ADDENDUM NO. #0

TRACK & FIELD IMPROVEMENTS

Rio Mesa High School

April 10, 2020

AD0-C1

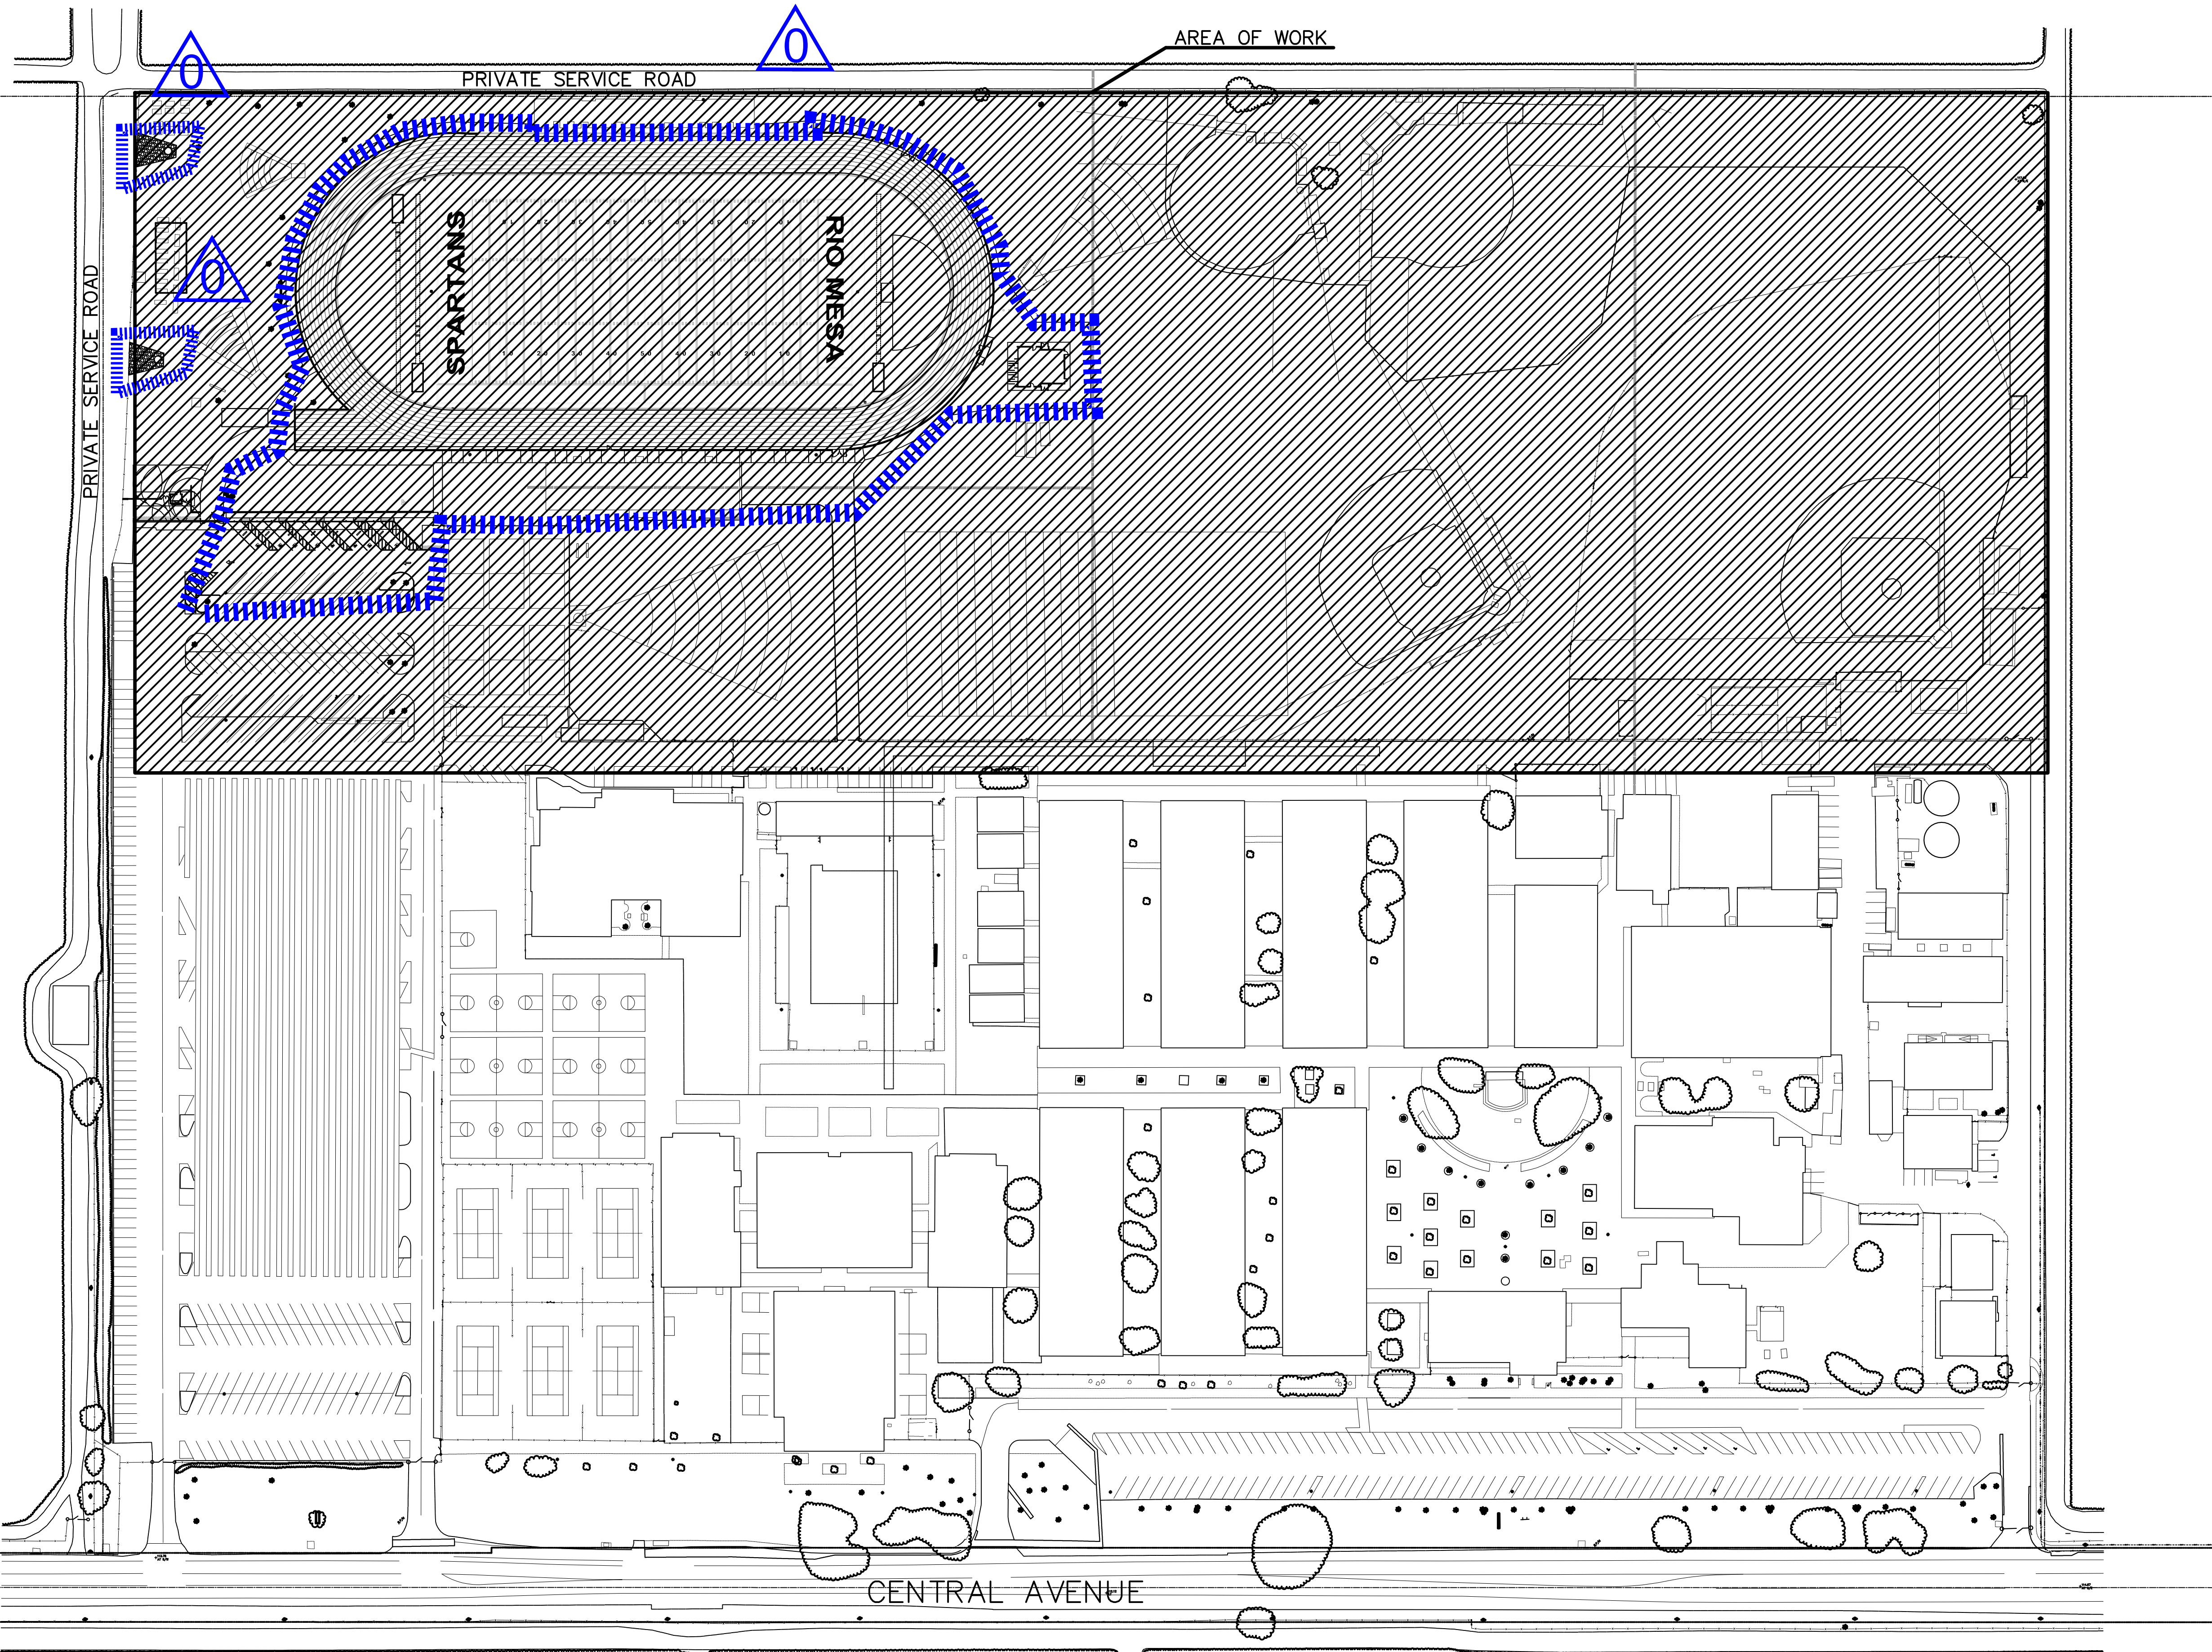
- 3.1.1.1.** Drawing C1.0: Revised Drawing per AD0-C1, see narrative.
- 3.1.1.2.** Drawing C2.0: Revised Drawing per AD0-C2, see narrative.
- 3.1.1.3.** Drawing C2.1: Revised Drawing per AD0-C3, see narrative.

- 3.1.2.1. Drawing C1.0/AD0-C1 - Area of work has been revised as shown on this sheet.
- 3.1.2.2. Drawing C2.0/AD0-C2 - Only work within outlined area is included in scope of this project and bid. Any work shown outside of the delineated area is not part of this project.

CONSTRUCTION PLAN

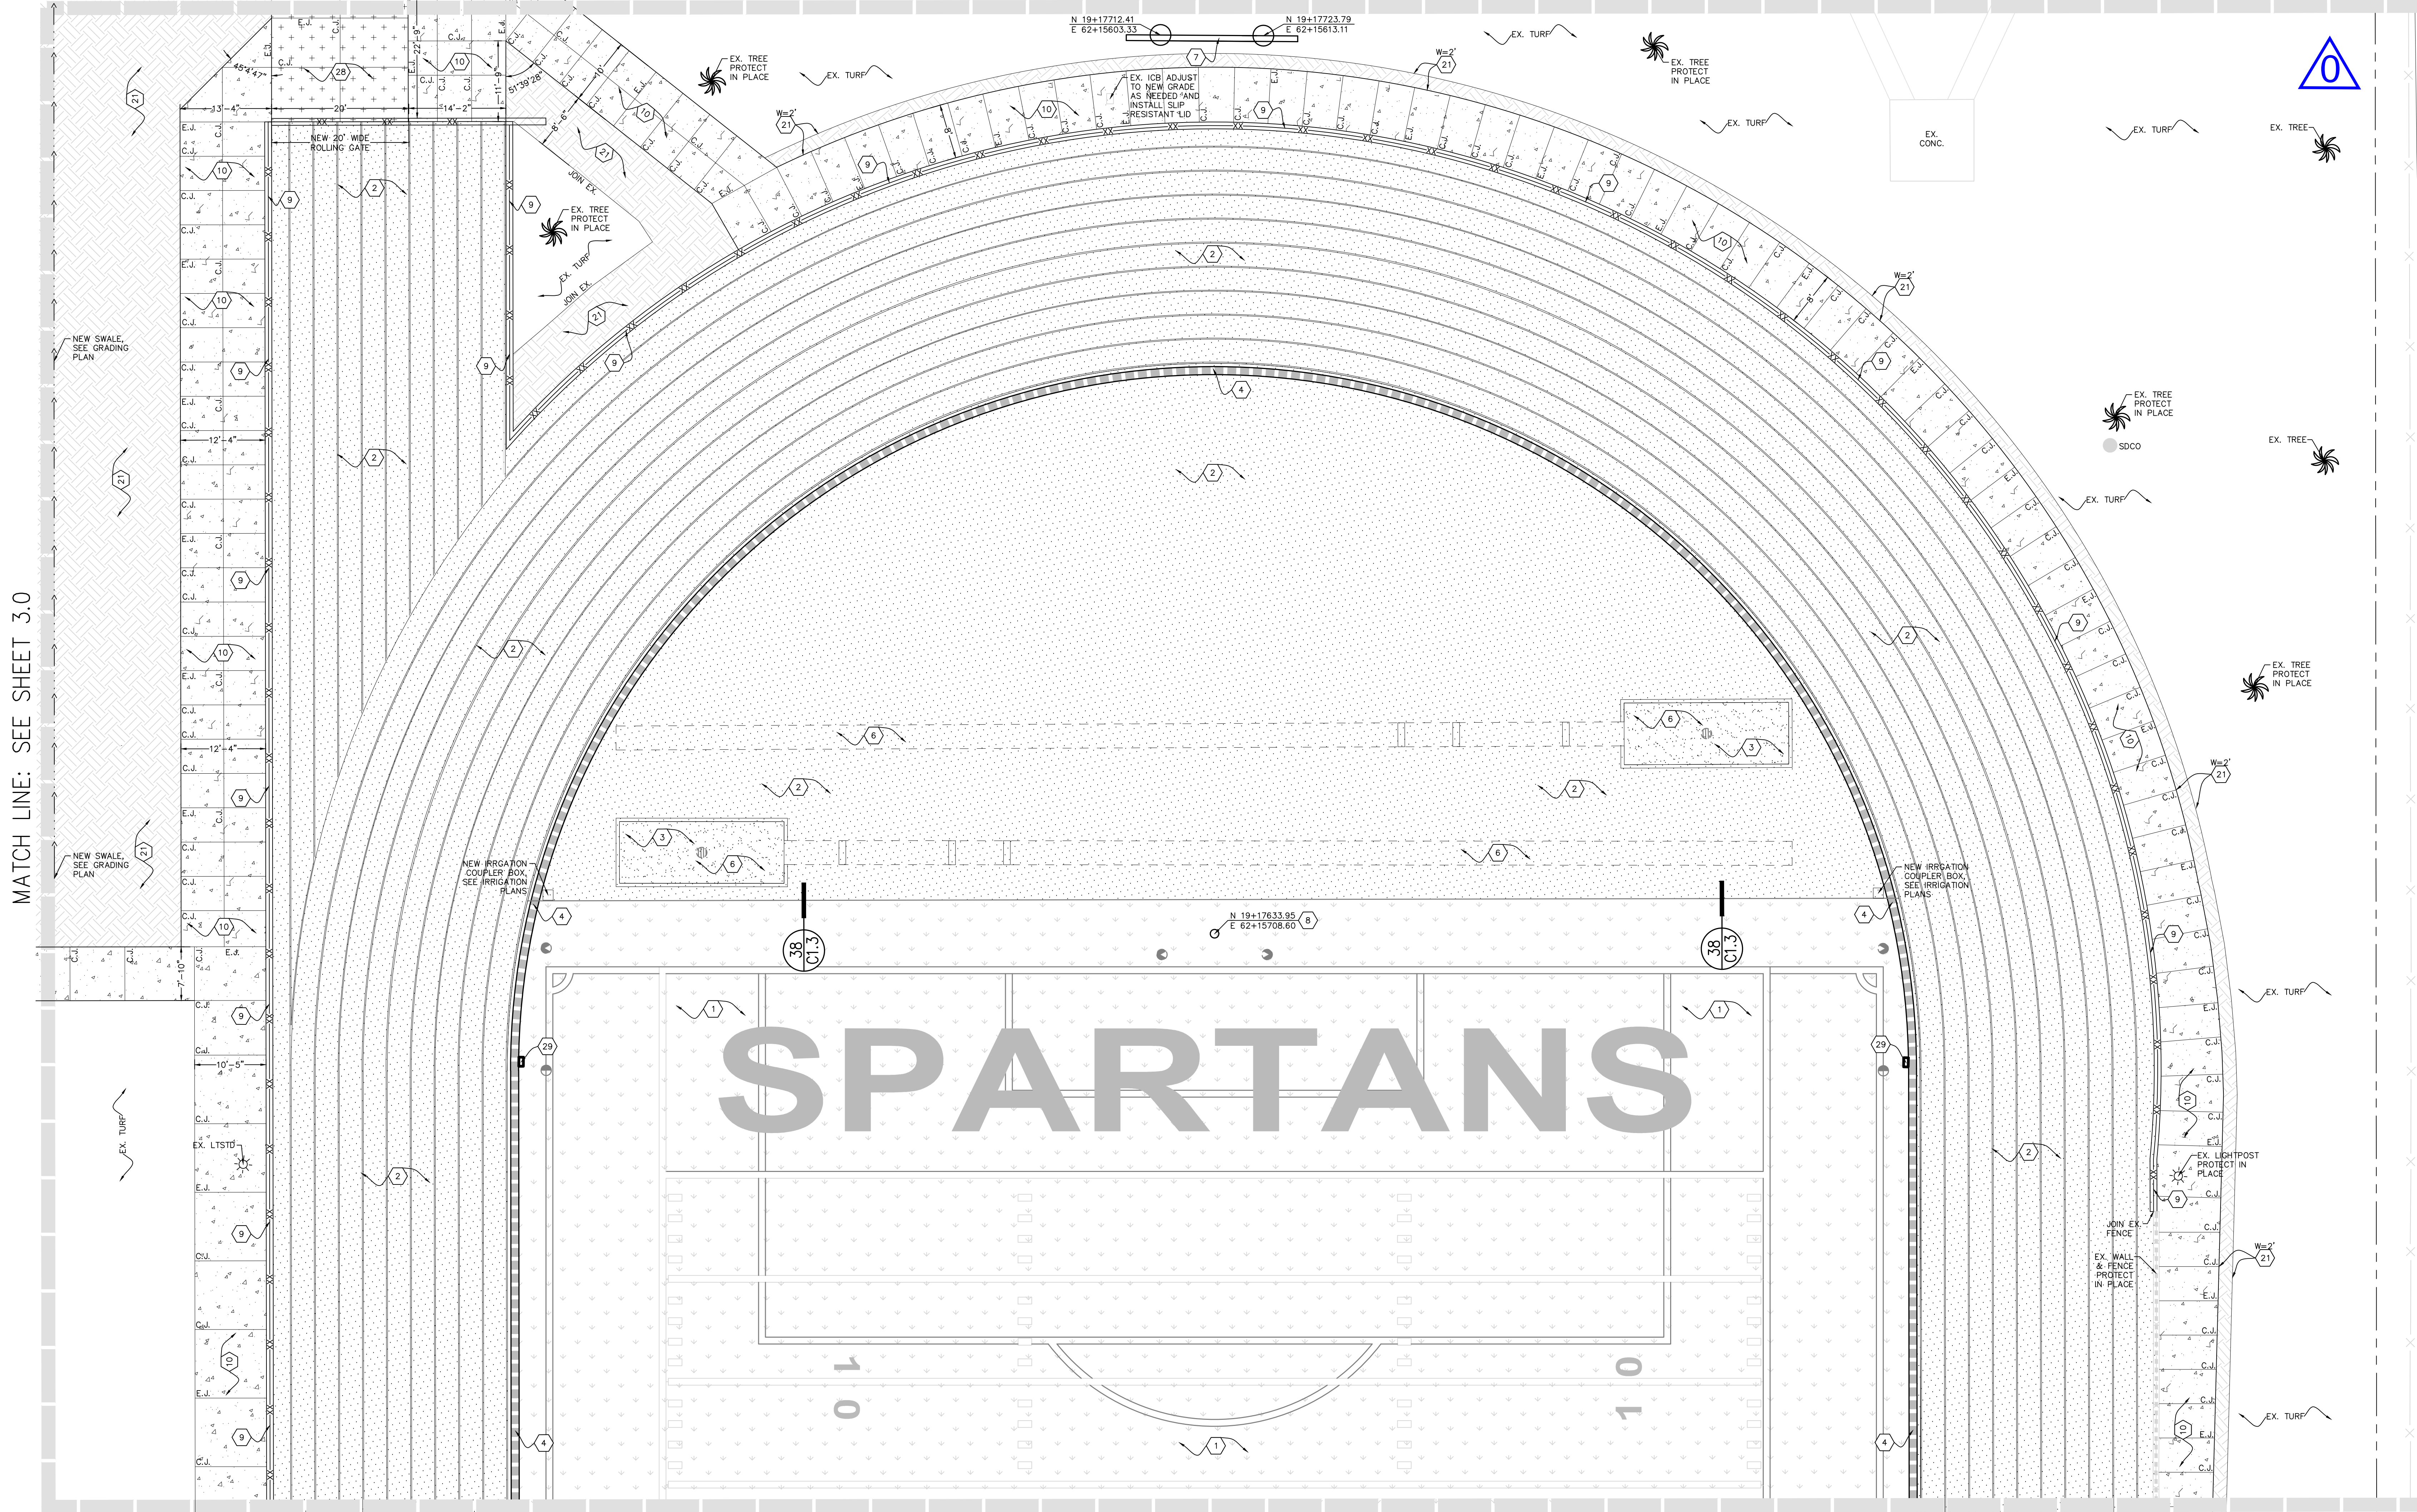
- 3.1.2.4. Drawing C3.0/AD0-C4 - Only work within outlined area is included in scope of this project and bid. Any work shown outside of the delineated area is not part of this project. Also, we have included a note on plan requiring contractor to gently transition from new improvements tying back to existing improvements via transitional AC paving (3" thick). Directional slopes shall not exceed 4.9% and also cross slopes shall not exceed 1.8%.

AD0-C5

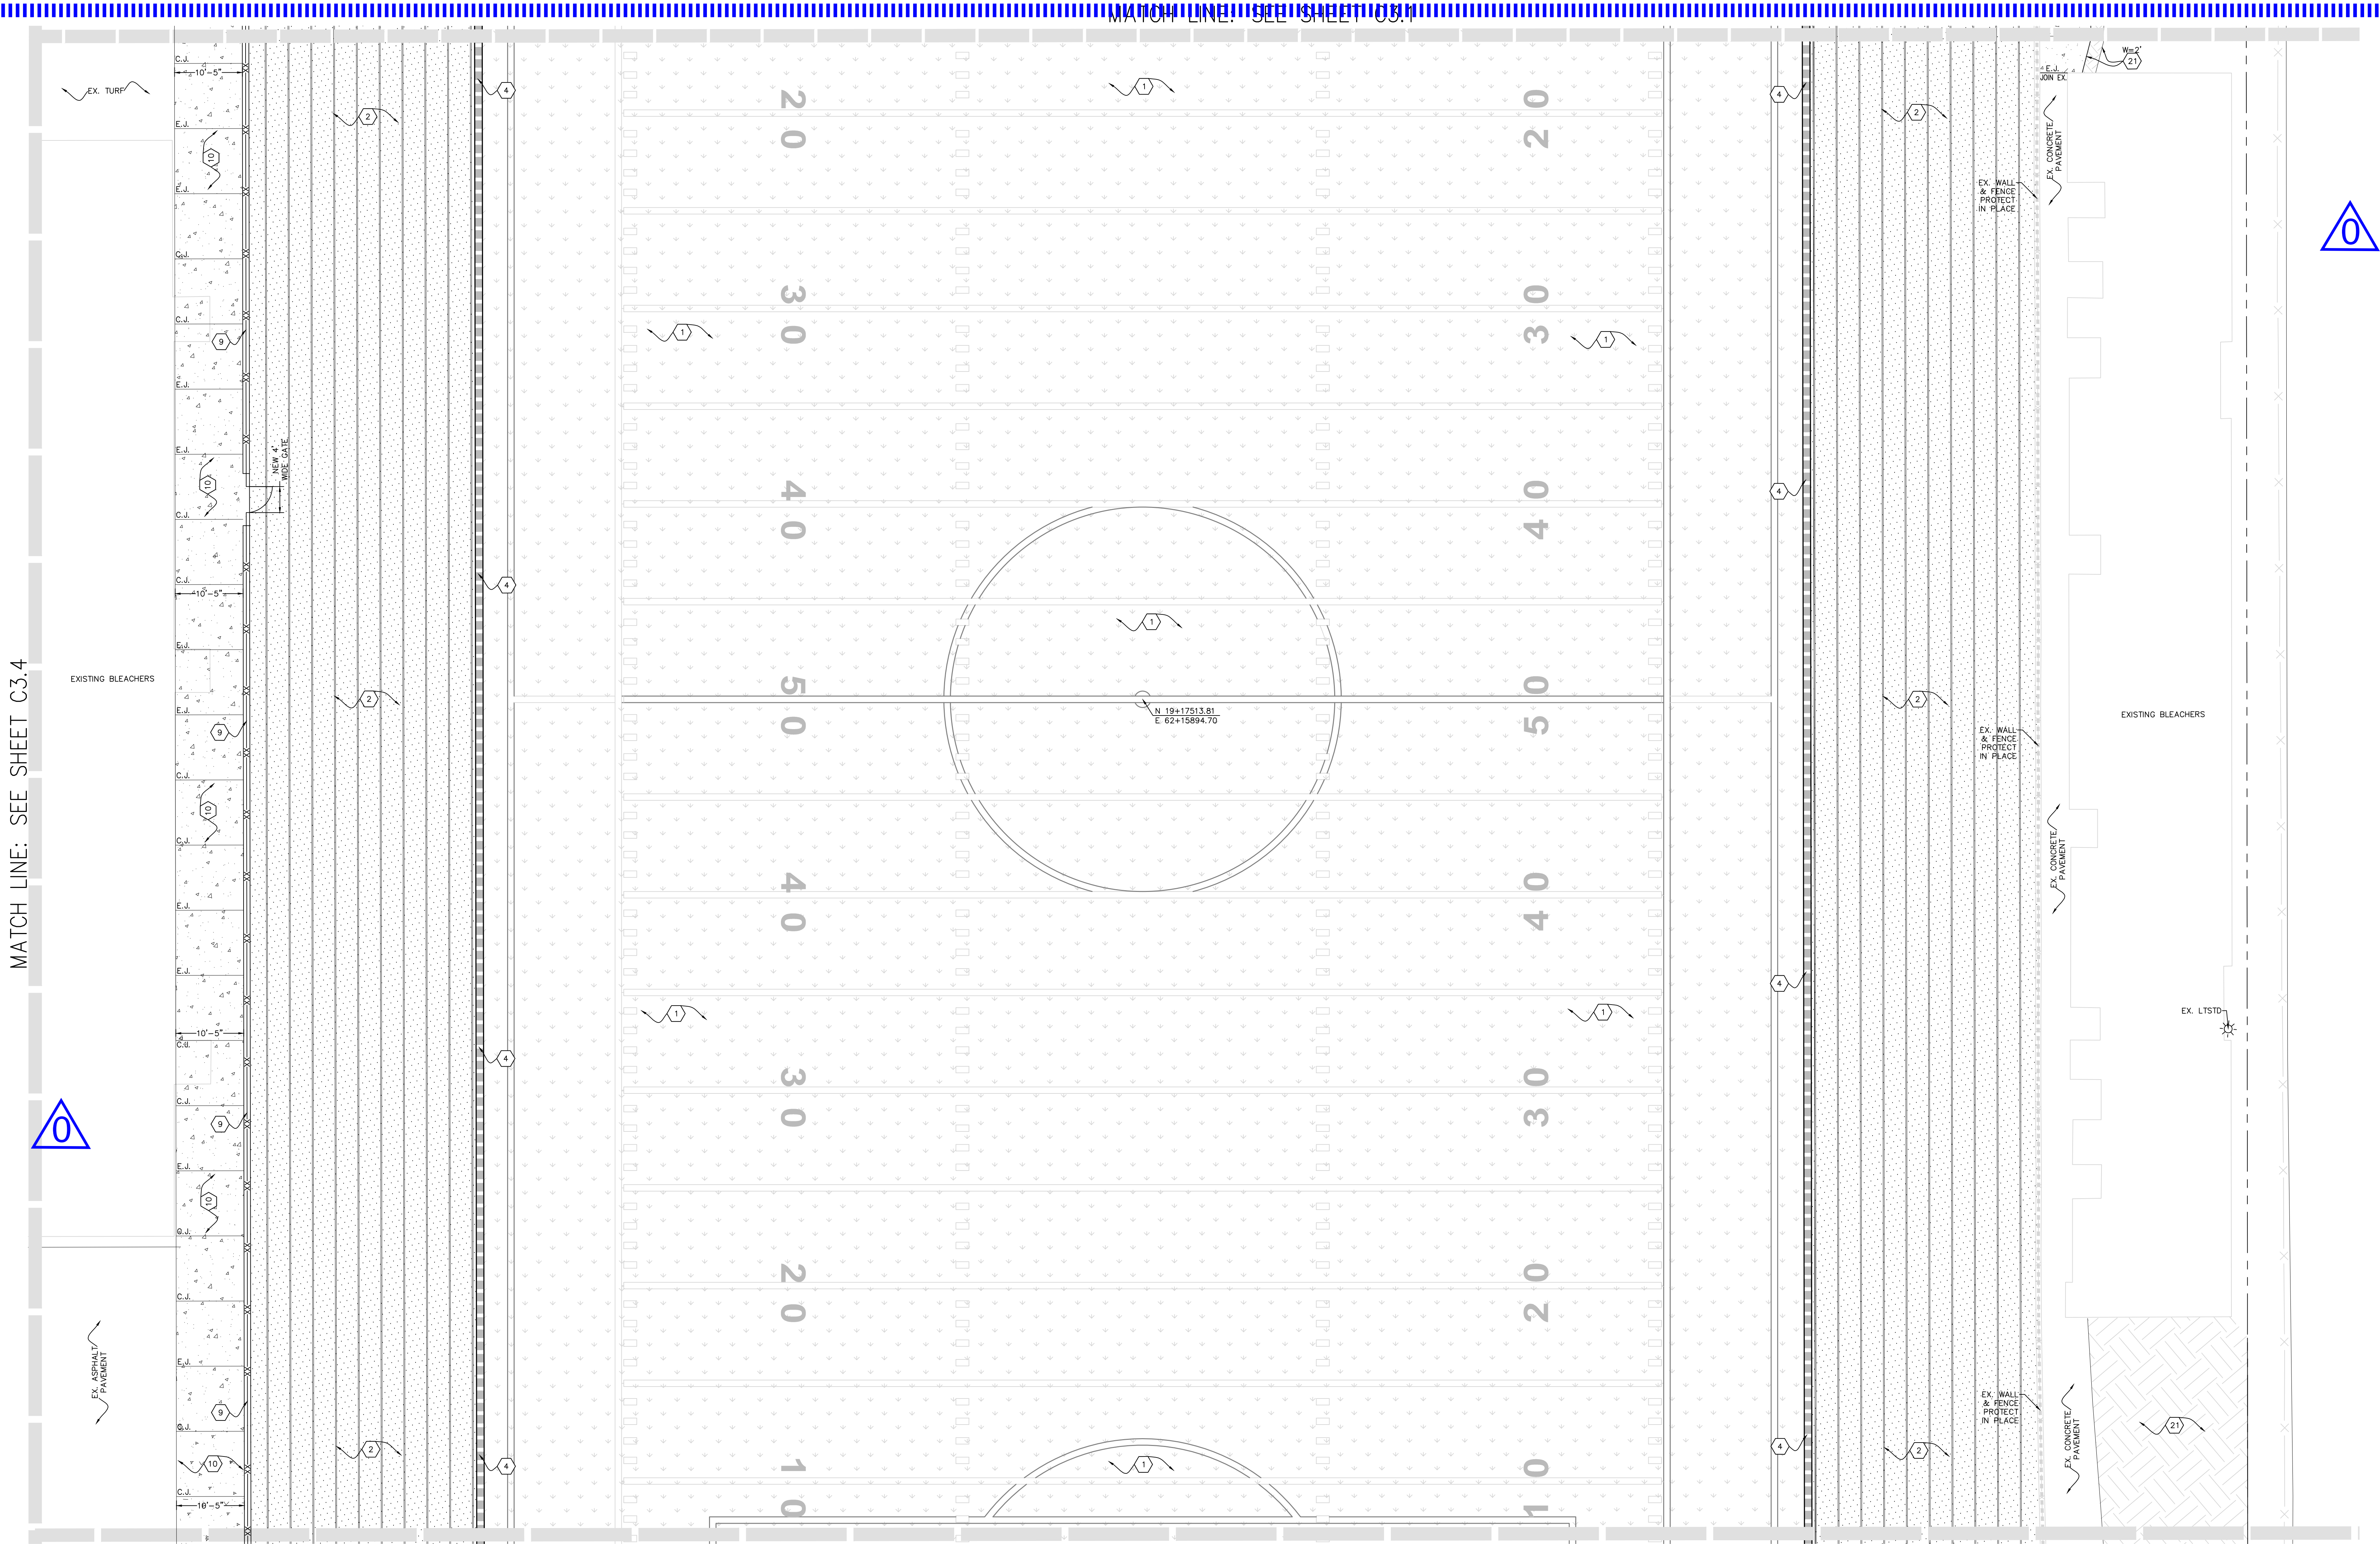
- 3.1.2.5. Drawing C3.1/AD0-C5 - Only work within outlined area is included in scope of this project and bid. Any work shown outside of the delineated area is not part of this project.
